ADDENDUM NO. 2

CITY HALL 3RD FLOOR CAO REMODEL, PROJECT 21-50

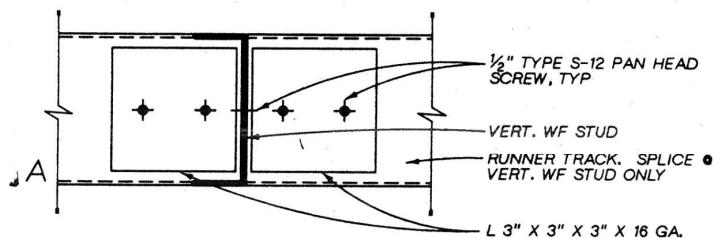
Question: Sheet A7.1, detail 12, calls for track attachment. What is this?

Answer: A typical runner track is as below.
